This addendum is issued by the Owner to all known bidders prior to receipt of Proposal. Bidders shall acknowledge receipt of this Addendum by so indicating on the Proposal Form. All information and instruction given herein shall become a part of the Contract Documents.

PHOENIX ACADEMY OMAHA
APMA Project # 15008
7 August 2015

ADDENDUM # 2

PROJECT Phoenix Academy Addition and Renovation

FINISH PLANS - LOWER LEVEL & FIRST FLOOR

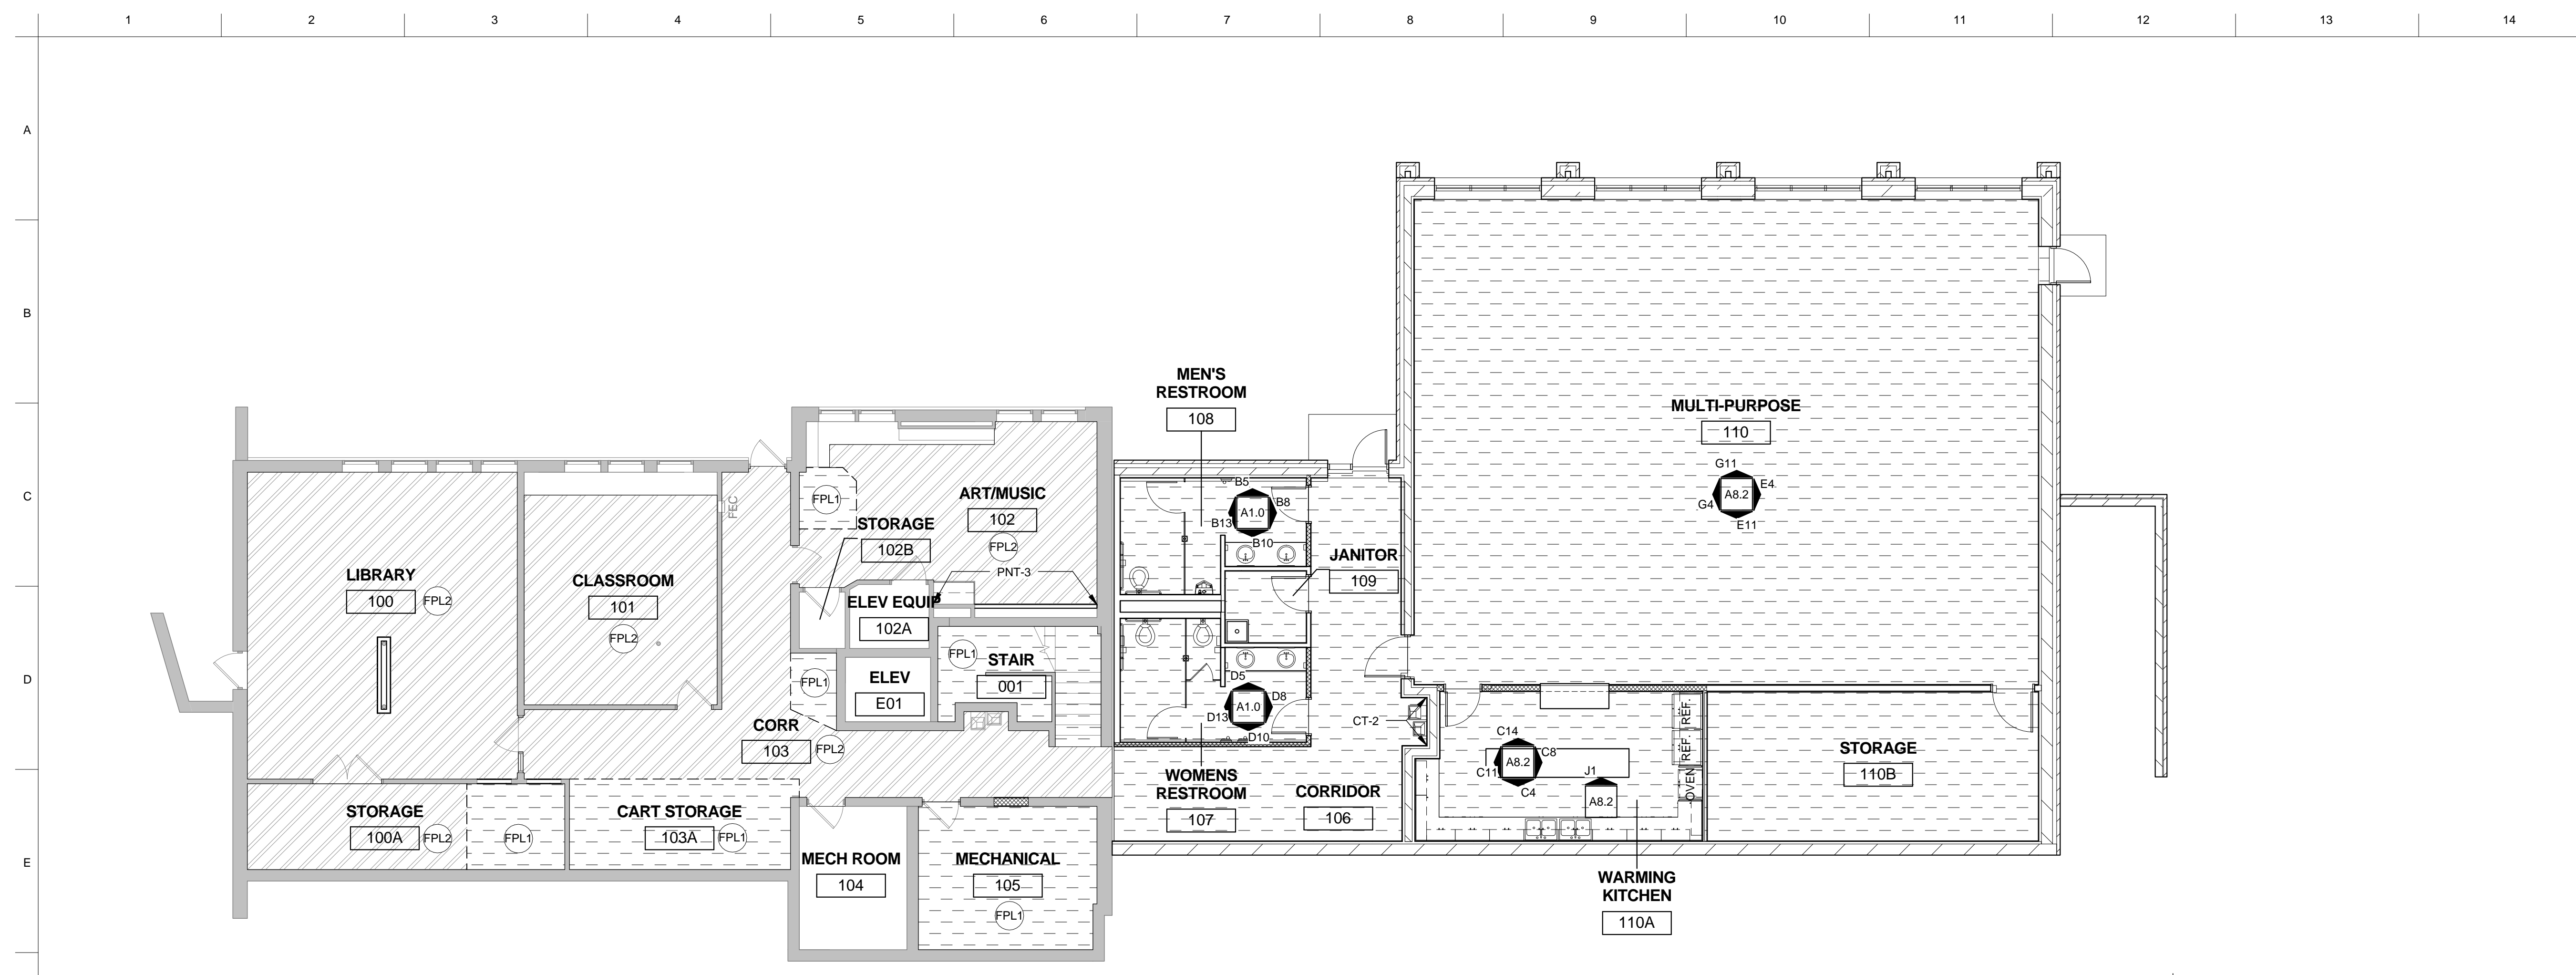
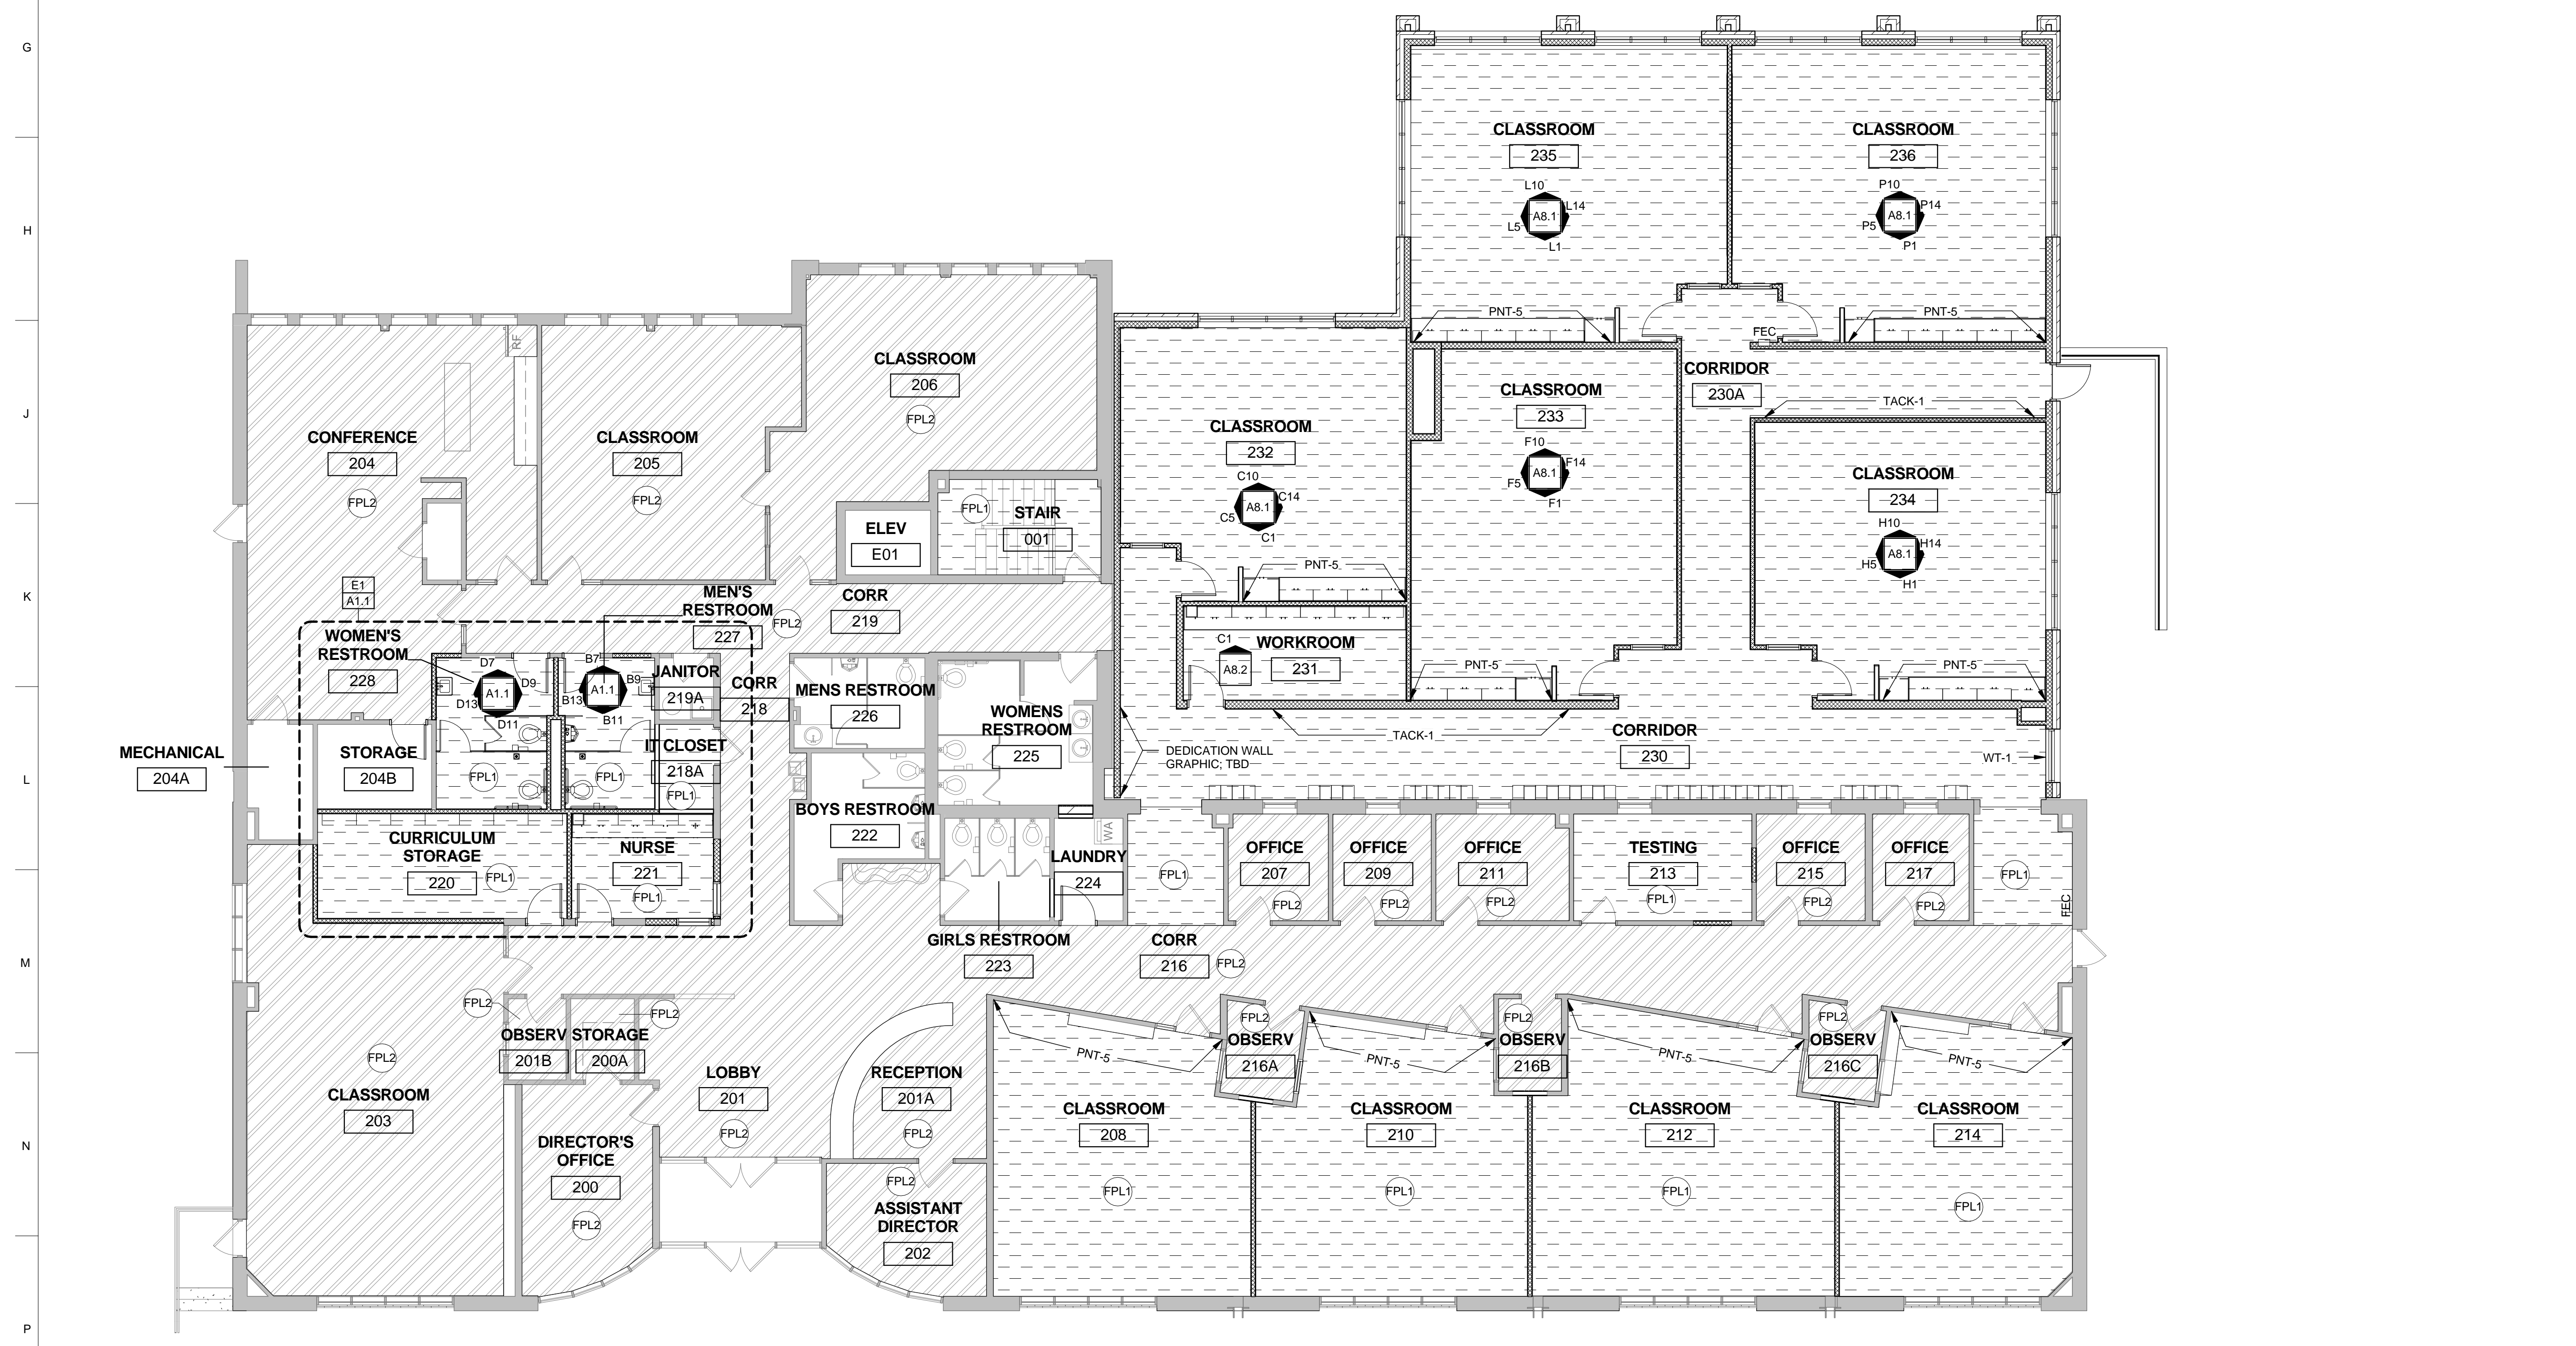
- 1. SHEET AD1.0 – DEMOLITION PLANS – LOWER LEVEL & FIRST FLOOR
- 2. SHEET A9.1– FINISH PLANS – LOWER LEVEL & FIRST FLOOR
